MetroWest Engineering, Inc.

RE: Windsor Place, 24 School Street, Wayland MA

I have received your letter to Linda Hansen, Conservation Administrator and the Wayland Conservation Commission, dated June 6, 2018 containing review comments regarding the site plan set for proposed redevelopment of the property located at 24 School Street in Wayland. The Civil Drawings, Hydrologic Analysis and Stormwater Report have been revised to address the comments from your letter. The Site Plans, Sheets One through Five have been revised bearing a revision date of July 5, 2018. The Stormwater Report has been revised and bears a revision date of June, 2018. The Revised Stormwater Report includes; the Hydrologic Analysis, Operation and Maintenance Plan, and supporting calculations documenting compliance with the Mass DEP Stormwater Standards.

Comment Response to Nover-Armstrong Letter dated June 6, 2018
Windsor Place, 24 School Street, Wayland

SHEET 5 OF 5

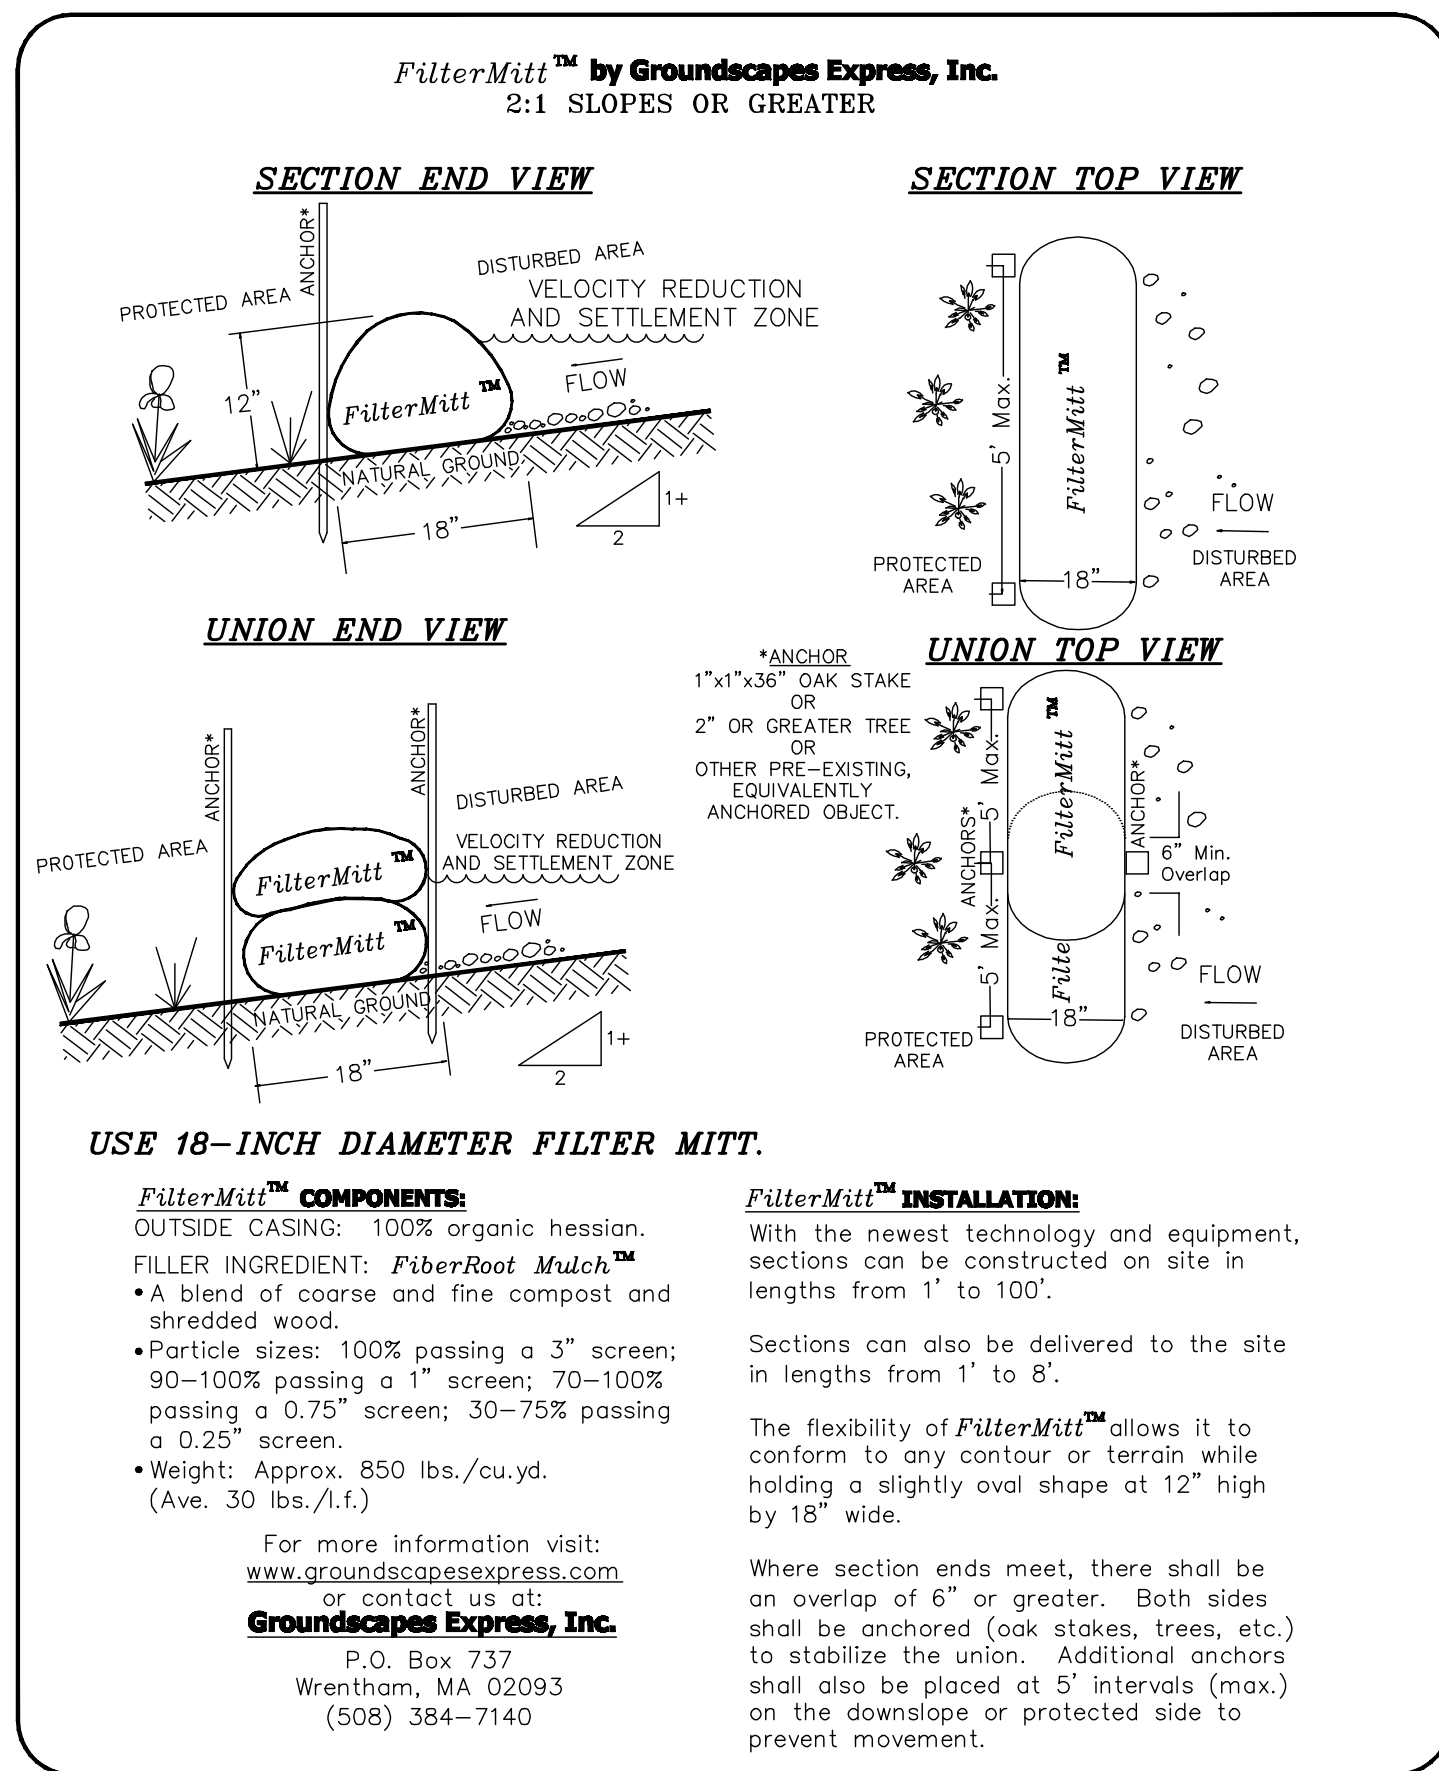
Design information to support the Level Spreader manifold sizing needs to be provided. The Detail and plan view its layout are inconsistent. Additional detail of the inspection cover should be provided as its is conceptual in nature. A second inspection point on the manifold inside of the wall should be provided. Future access for maintenance and/or repair of the manifolds and the outlet pipe on the south side of Unit 1B will be difficult.

Details for the construction of the inspection cover have been added to the Level Spreader Manhole Detail on the *Proposed Details Plan*, Sheet 5 of 5.
